TO: Mayor Rochelle Robinson, City of Douglasville
ATTN TO: Ryan Anderson, Zoning Administrator, City of Douglasville
FROM: Douglas R. Hooker, Executive Director
RE: Development of Regional Impact (DRI) Review

Name of Proposal: Douglas County Graduation, Multipurpose Arena DRI 3523

DOUGLAS COUNTY GRADUATION – MULTIPURPOSE ARENA DRI
City of Douglasville
Natural Resources Group Review Comments
January 24, 2022

Stream Buffers

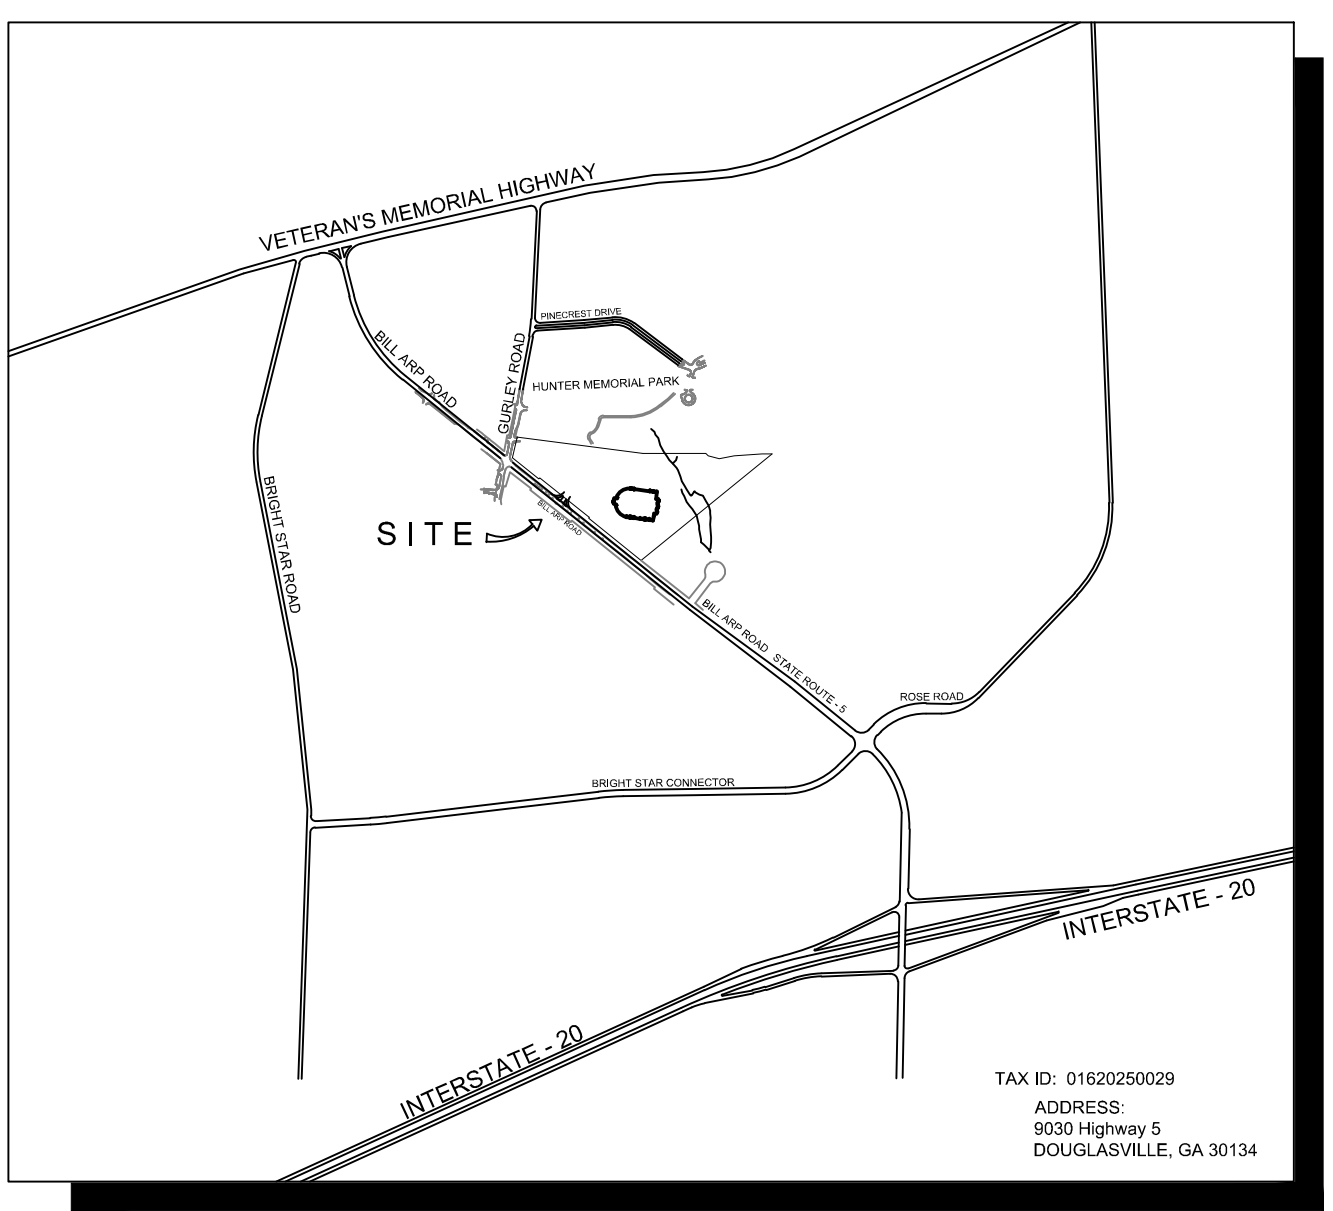
Both the USGS coverage for the project area and the project site plan show a blue line tributary to Anneewakee Creek on the eastern end of the proposed project site. The submitted site plan also shows a tributary to that stream at the southern end of the project site. The site plan shows buffers on both streams. Although not specifically identified, they appear to be 50-foot undisturbed stream buffer and additional 25-foot impervious setback required under the City's Stream Buffer Ordinance (and the Anneewakee Watershed Ordinance) as well as the State 25-foot State Erosion and Sedimentation Control buffer. Intrusions into the City buffers are shown on both streams for grading and parking. These intrusions may require variances under the both the City Stream Buffer Ordinance. Any intrusions into the 25-foot buffer may require variances from and the State 25-foot State Erosion and Sedimentation Control buffer. Any unmapped streams on the property may also be subject to the City buffer ordinance. Any unmapped State waters identified on the property may also be subject to the State 25-foot Sediment and Erosion Control buffer.
